August 28, 2014

Chairman Norm Fontaine and Planning Board Members  
Amenia Town Hall  
Amenia, NY 12501

The purpose of this memo is to address several of Mr. Janes' comments presented during the August 21, 2014 Planning Board Meeting.

*2014 Proposed MDP Visual Simulation*

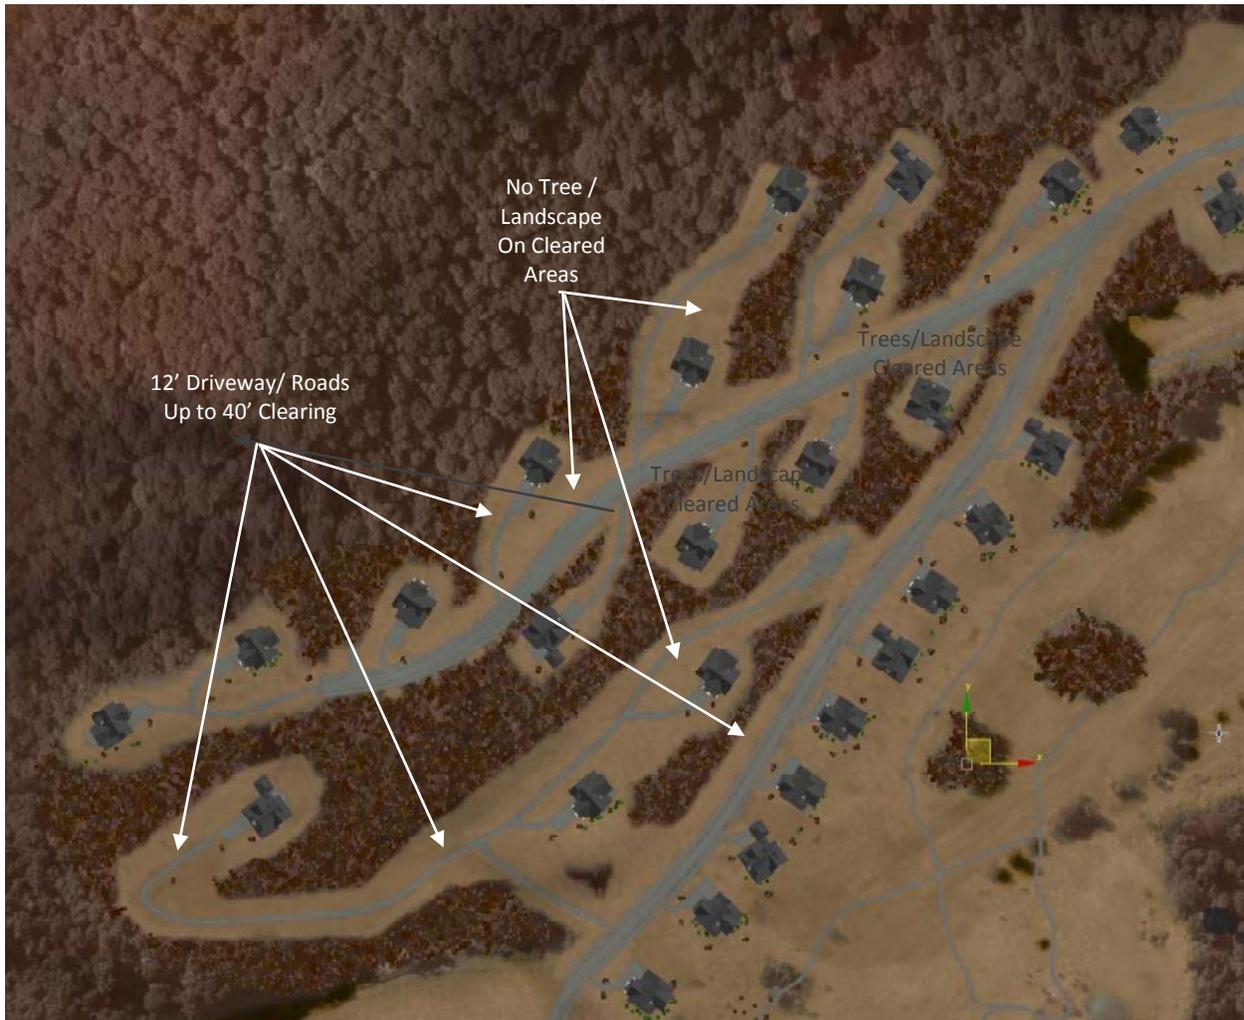
- 4- **Comment:** Approved 2009 MDP compared with the 2014 Proposed Plan. (Estate Homes at south end are visible from several viewpoints)

In addition to the above mentioned comparison, the comment mentions that Section 2 of the Estate Homes is visible within several viewpoints. More specifically Mr. Janes describes the action as much more visible than the previous simulations. Please note the following:

- The 2009 FEIS Visual Simulations did not include the houses to be relocated to Section 2 of the Estate Homes. This relocation was due to minimizing disturbances within a stream and steep slopes in the northern portion of the site. Therefore it would be incorrect to compare one to the other.

- The new simulations were performed using a different methodology than the 2009 FEIS Visual Simulations. A worst case scenario was used for building colors, landscaping, grading and tree clearing. Additionally, 2014 uses individual larger scale images vs panoramic simulations utilized in 2009. As stated in Mr. Janes memo, the 2009 FEIS Visual Simulations shows that “through the use of subdued tones for architectural roofs and facades...site structures are reduced in impact.” As shown in the images below, the 2009 FEIS Simulations utilizes subdued colors and schemes while the 2014 Proposed MDP Visual Simulation follows Mr. Janes recommendation and utilizes a worst case scenario by incorporating white and light colors for “ALL” trims, windows, porches and columns.

Furthermore, Section 2 of the estate homes in the new visual simulations shows greater tree clearing and grading than what is planned for and includes minimal landscaping within the graded or lot areas. For example, 18 foot wide roadways are simulated as having a total clearing path of 50 feet. **It should be noted that these examples would be in direct conflict with the Design Guidelines for this area.** However, during the review process it was decided to use this approach rather than debate what trees would get cut down and which ones would not (especially since it is extremely difficult to predict this on a simulation where the picture is over a mile away).

As depicted in the image below, the 2014 worst case approach resulted in 12' driveways and 18' roads having up to 40 feet to 50 feet of clearing area and no trees in areas adjacent to roads or home sites. As noted by Mr. Janes comment that "on-site plantings are small and do little screening..." the result is an image with little to no screening and with brighter colors through the site.

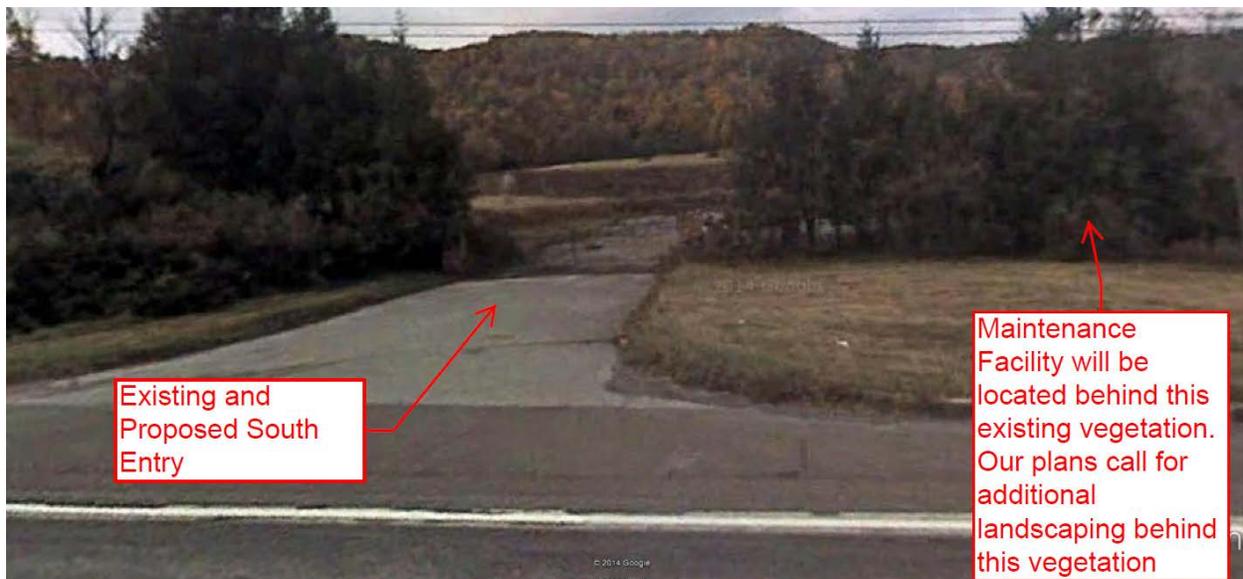
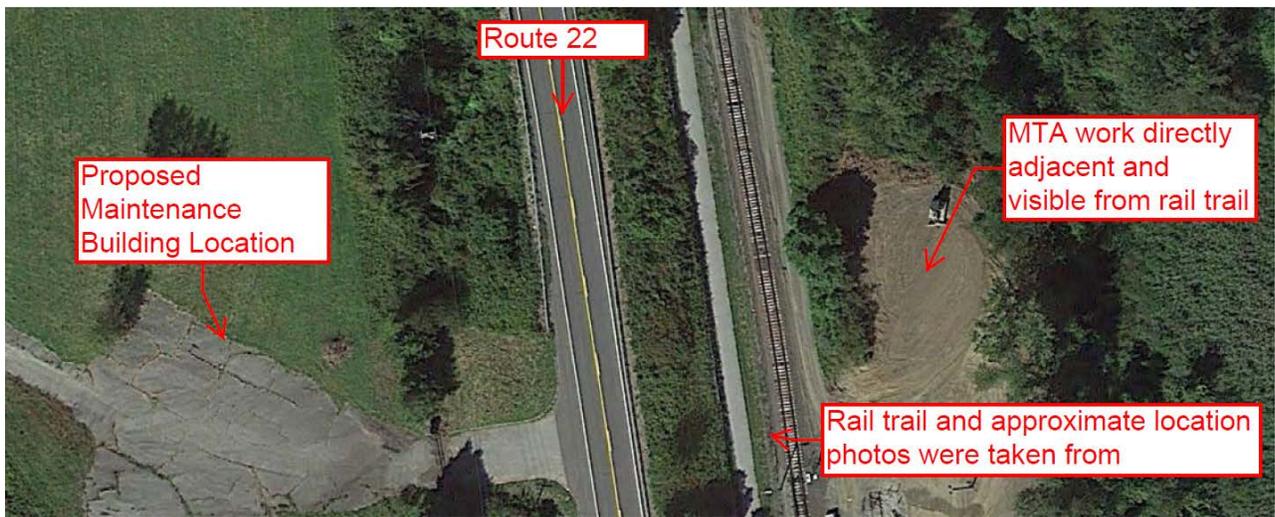
- f) Complies with landscape, architecture and fences requirements and rural siting principles.

**Response:** The hedge at the hairpin curve uses a fence and the WWTP requires a fence for safety. The Planning Board can decide if the fence at the hairpin curve is something they would like kept in the plan. If allowed the proposed plan can include an aesthetically pleasing fence at the WWTP given that it also complies with safety requirements.
